METRO PLANNING COMMITTEE OF THE TOWN PLANNING BOARD

MPC Paper No. 10/16

**Submission for Compliance with
Approval Condition (a) of Application No. A/K20/126**

**Proposed Public Utility Installation (Dry Weather Flow Interceptor)
in “Open Space” Zone and area shown as ‘Road’
Government Land, Hoi Fai Road, Tai Kok Tsui, Kowloon West**

繪圖
DRAWING
AA - 1

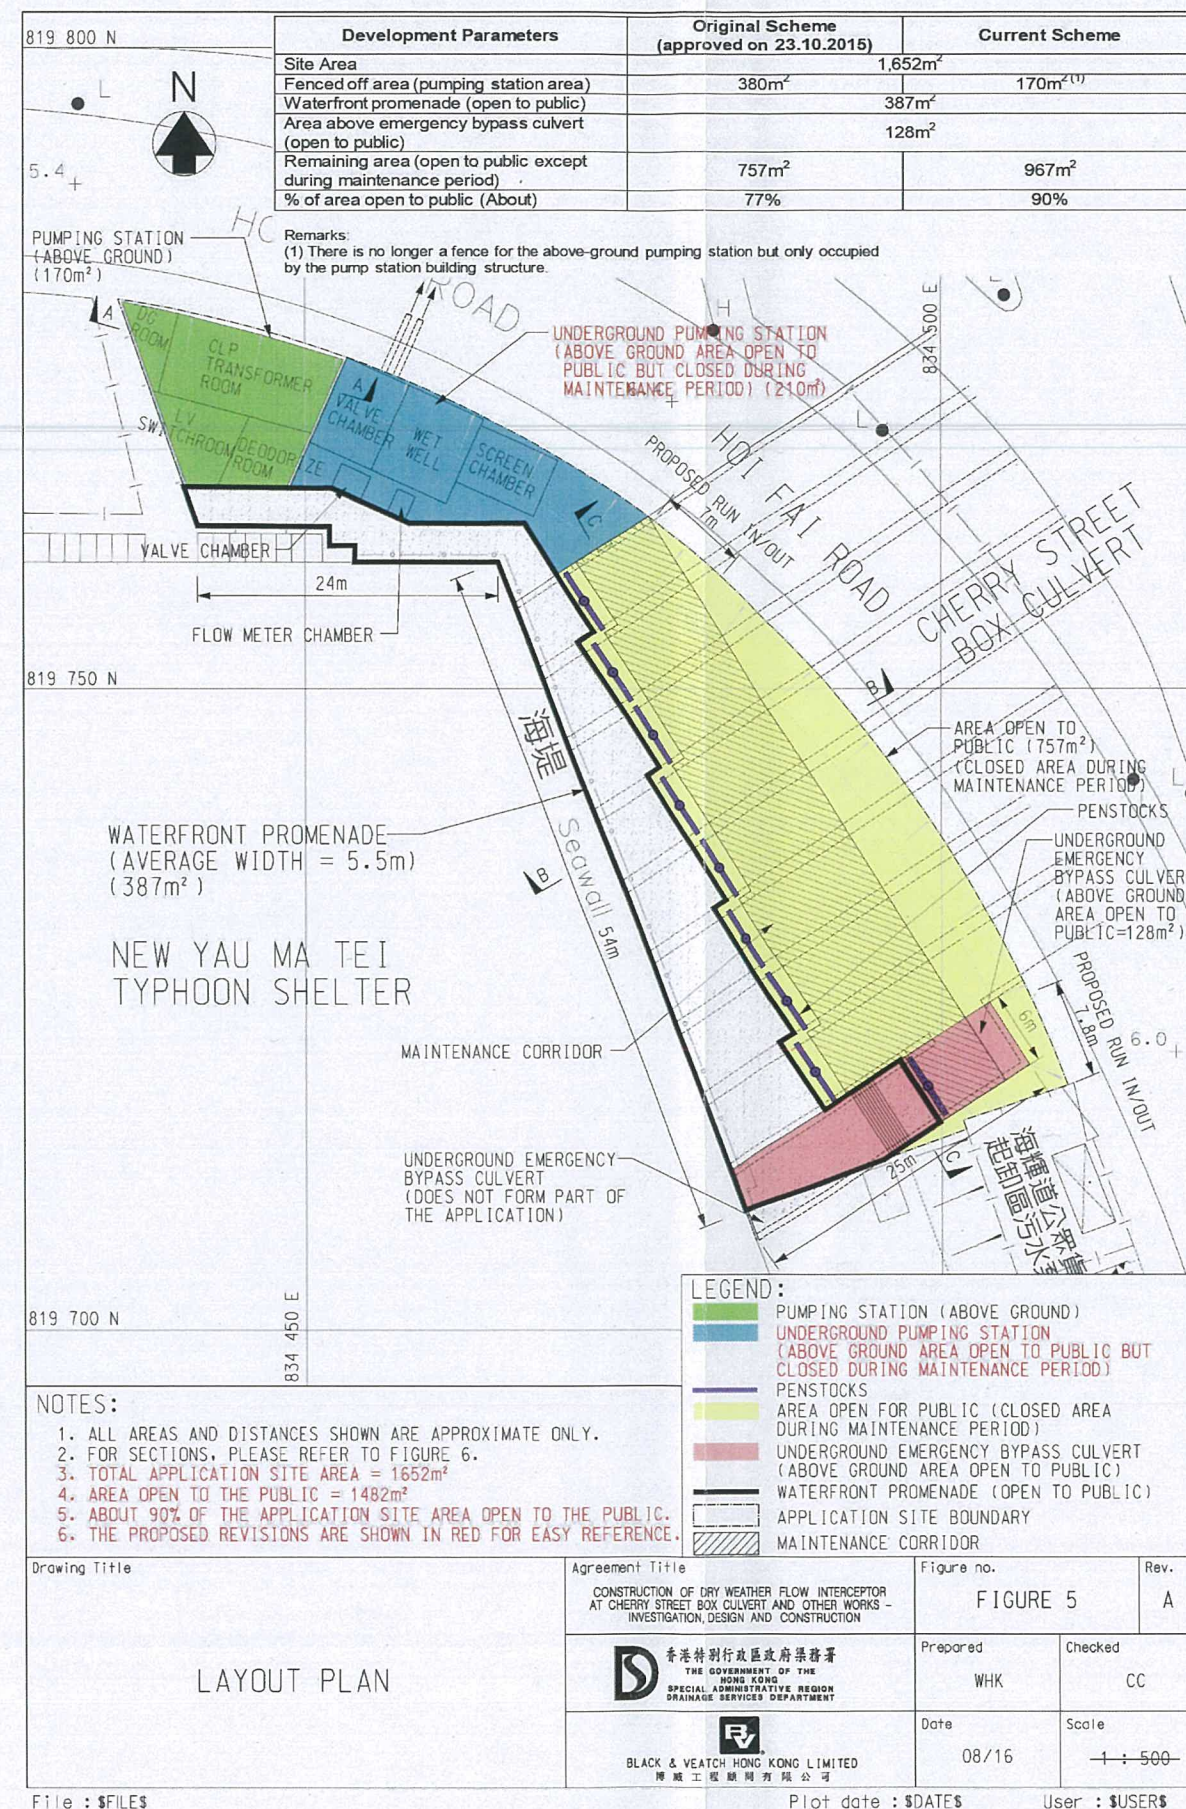
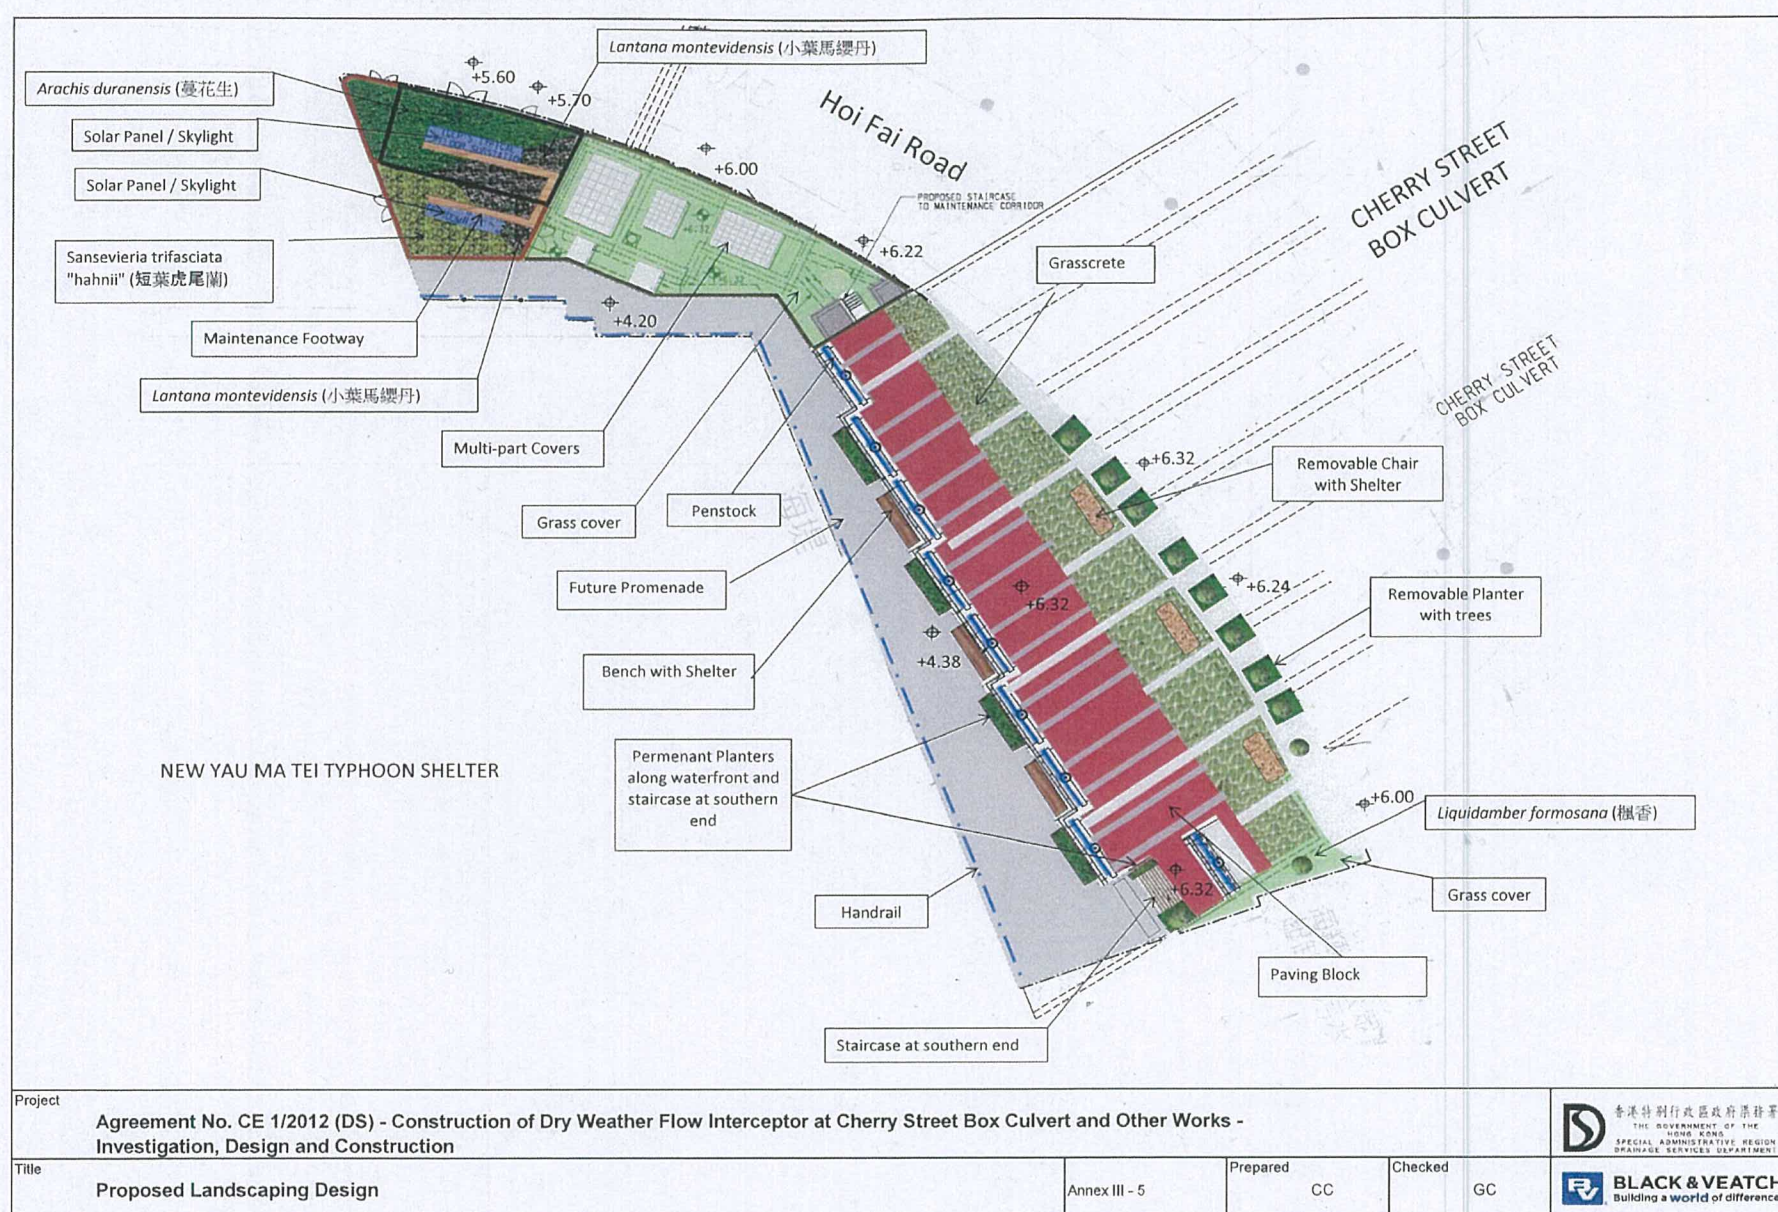
(1) There is no longer a fence (**Appendix Ia**) for the above-ground pumping station at the northern most of the Site but only occupied by the pumping station building structure (**Drawing AA-1**).

(2) The fence wall above the underground pumping station has been removed in the revised design (**Drawings AA-1 and AA-3**).

繪圖
DRAWING
AA - 2

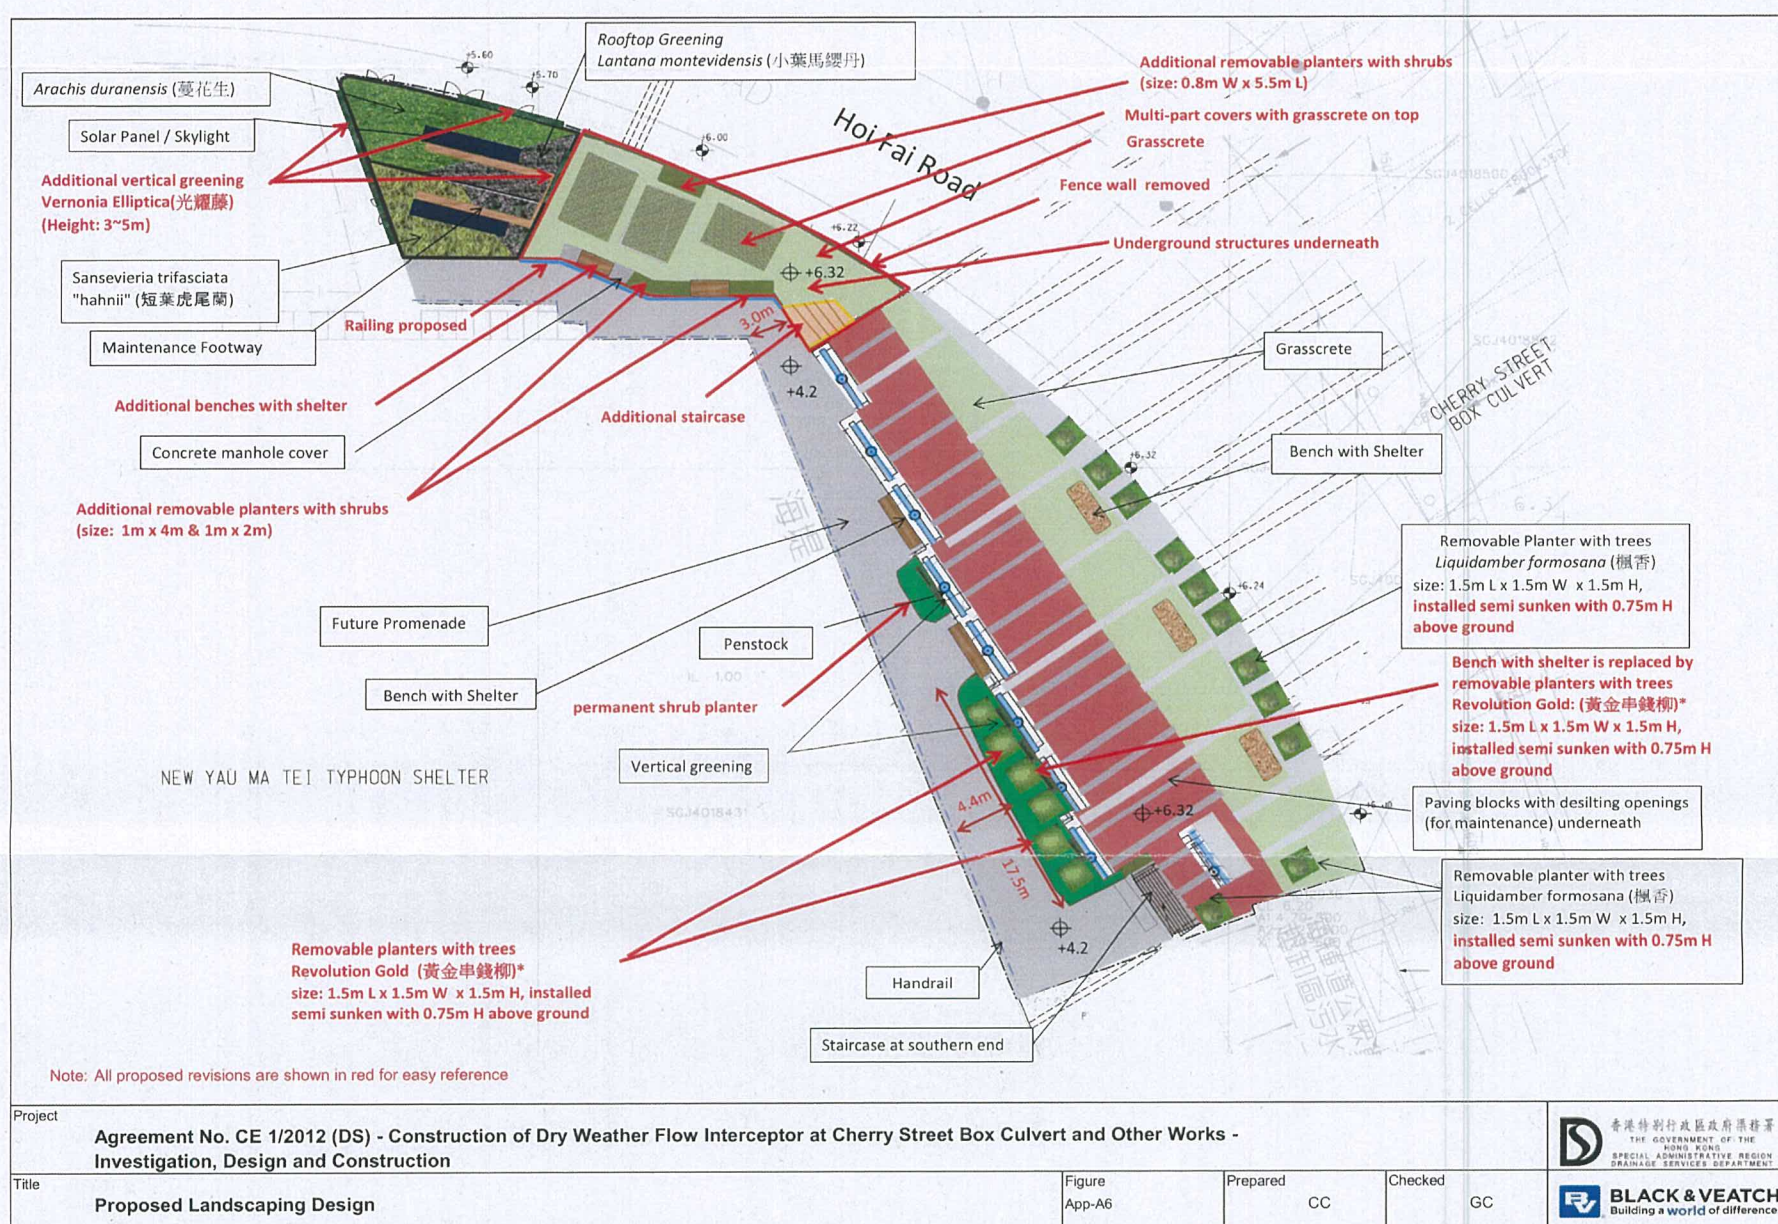
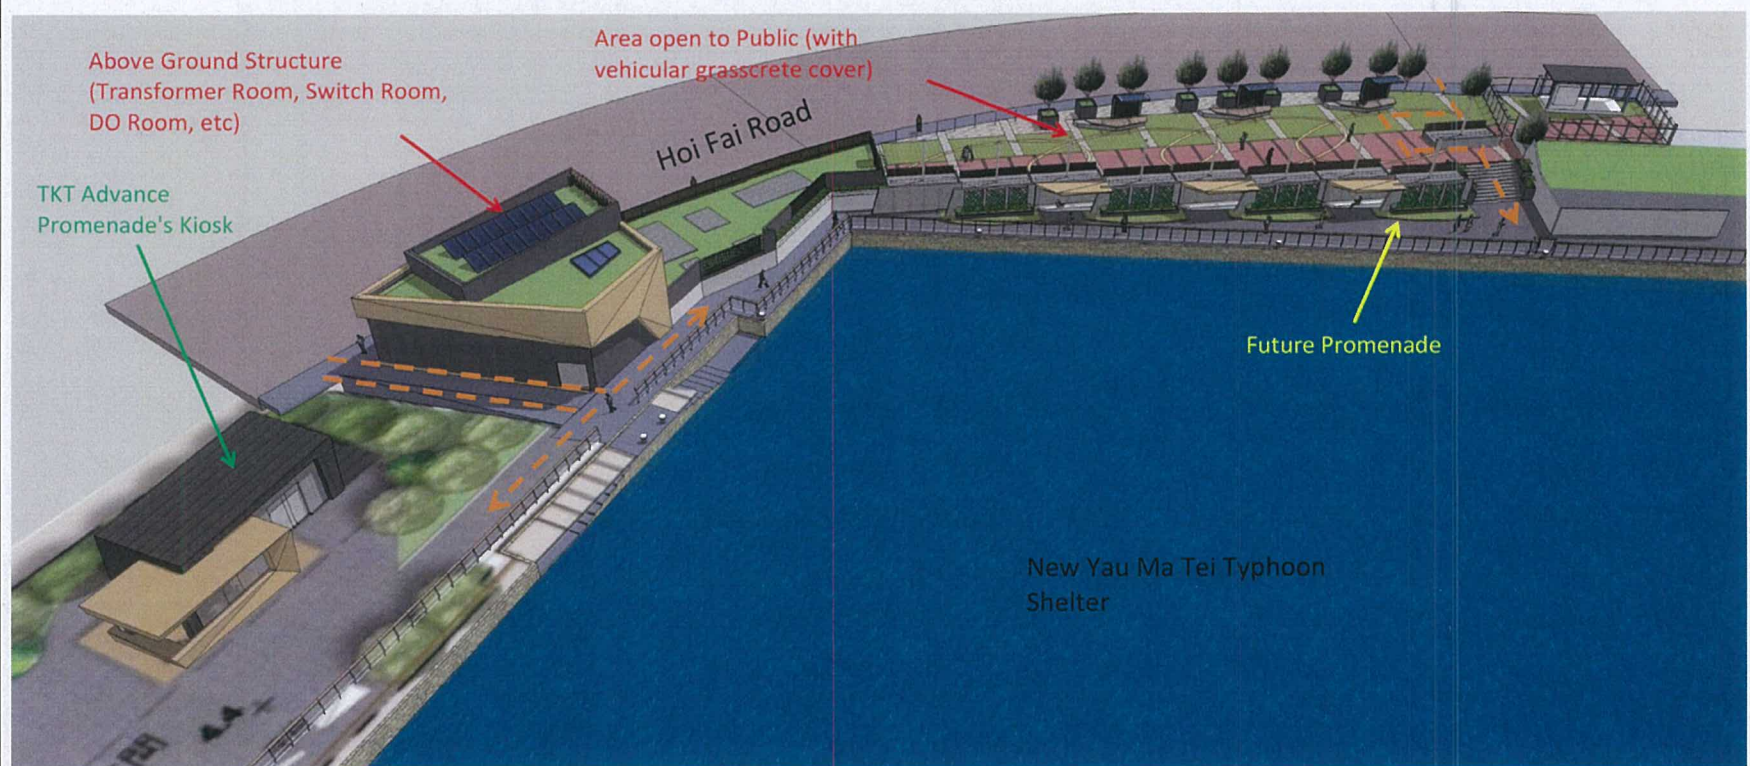
- (g) Shrubs will be planted at the promenade to improve the appearance of the planters and six additional trees on removable planters, *Melaleuca bracteata* (黃金串錢柳) (**Drawing AA-5**) have been proposed towards the southern side of the waterfront promenade, in addition to the proposed shelters, landscape area and vertical green walls under the original scheme, in order to maximise tree planting opportunities along the promenade (**Drawings AA-2 and AA-5**).

- (h) The planter boxes will be designed to enhance visual appearance matching with the environment. The height of all tree planter boxes have been reduced and semi-sunken to a height of 0.75m above ground to look less massive and enhance visual openness while complying with the required soil depth of 1.2m (**Drawings AA-2 and AA-5**).
